Bulletin No.: 06-02-32-007F

Subject: Clunk, Knock or Rattle Noise From Front of Vehicle While Driving or Turning Over Bumps at Low Speeds (Diagnose Noise and Perform Outlined Repair)

This bulletin is being revised to update the models years and revise the information for Correction 2. Please discard Corporate Bulletin Number 06-02-32-007E (Section 02 - Steering).

Electric Assist [Power Steering](#)

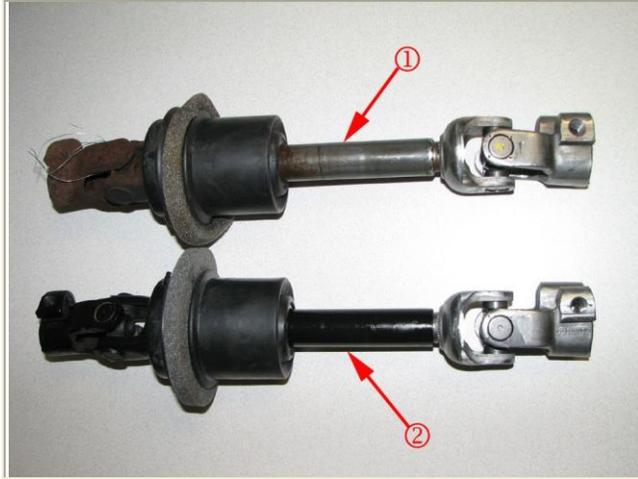
Revised design intermediate shafts went into production in the 2009 model year and are the only design currently available through GMSPO since approximately September 2008. Since any model year vehicle could have had a second design shaft installed, it is critical to identify it before proceeding. The revised design intermediate shafts will NOT tolerate any type of lubricant per the following instructions. Adding lube to the second design shafts will cause a clunk noise in a very short period of time. Use the following pictures to identify which design of shaft you are servicing.

First Design - Bare Steel Tube (Lube OK)

In the unlikely event that the source of the noise is identified as a second design shaft with black painted tube, it must be replaced.

Second Design - Black Painted (DO NOT Lube)
Hydraulic Assist [Power Steering](#)

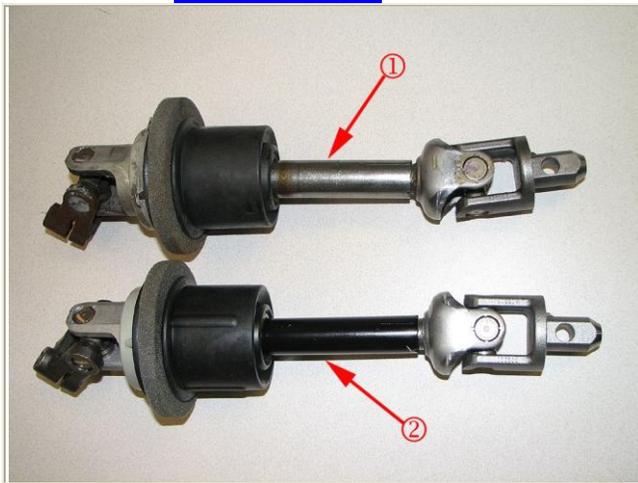
First Design - Bare Steel Tube (Lube OK)

Second Design - Black Painted (DO NOT Lube)

Correction 2

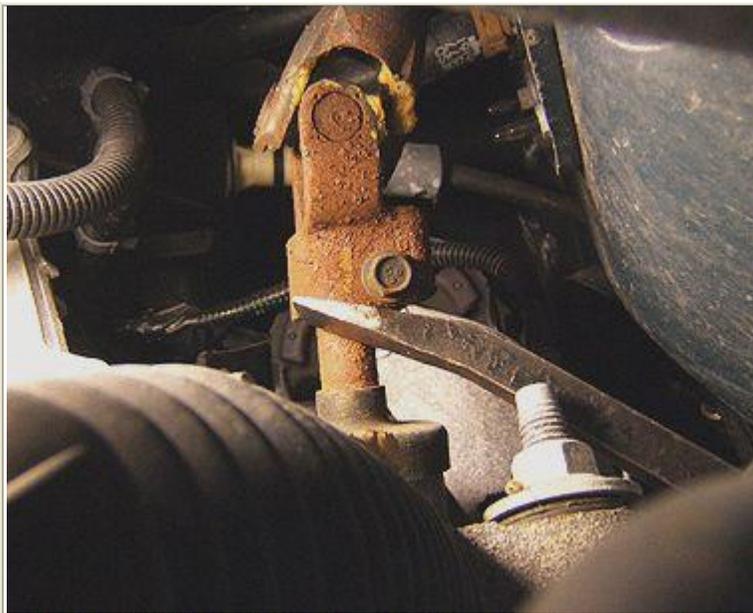
There may be interference between the clamp and the [steering gear](#) input shaft. The clamp is beveled and if forced down on the input shaft too hard, it may cause a loose fit with the intermediate shaft to input shaft joint.

1. Remove the intermediate shaft pinch bolt at the [steering gear](#) end.
2. Install a new bolt, GM P/N 26058124 (Chevrolet, Pontiac) or P/N 26046722 (Saturn), but do not tighten the bolt at this time.

3. Pry the clamp up using a pry bar to position the bolt into the upper part of the groove as shown above. This will position the clamp off the bevel.
4. While keeping the clamp in the upper position, tighten the bolt.
Tighten
Tighten the bolt to 49 Nm (36 lb ft).
5. Verify that the clunk noise is no longer present.

Correction 3

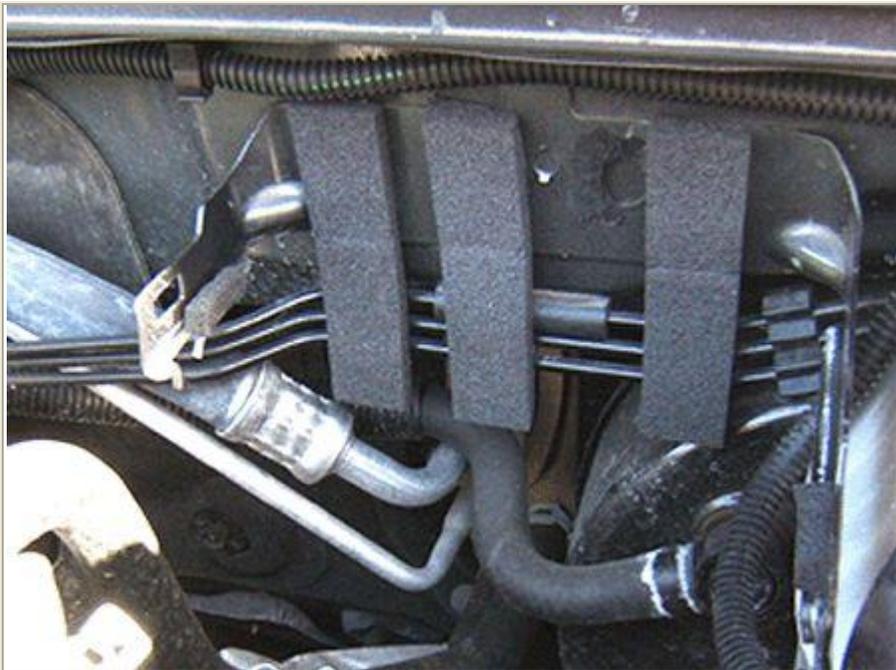
Some customers may comment on a knocking or rattling type noise from the front of the vehicle when driven at low speeds and over bumps. The noise only occurs when the [steering wheel](#) is in the straight ahead position and sounds like the noise is in the left [suspension](#) of the vehicle or directly in front of the driver.

1. Ensure the noise is not caused by Condition # 1.
2. Determine the source of the noise. Install the chassis ears at the following locations:
 - sway bar link - one side at a time

- upper [strut mount](#) - one side at a time
 - [steering gear](#) near the pinion area
 - base of the [steering column](#) housing
 - radiator surge tank

3. If the noise is coming from the upper [strut mount](#) or sway bar link, replace as necessary and retest.
4. For 2004-2006 Chevrolet and Pontiac model year vehicles, the noise may be coming from the radiator surge tank area. (The 2007 model year vehicles use a different style radiator surge tank - refer to Step 9.)

5. If the noise is coming from the radiator surge tank, release the two retaining tabs holding the radiator surge tank and reposition the tank away from the attaching bracket and isolate with closed cell foam.
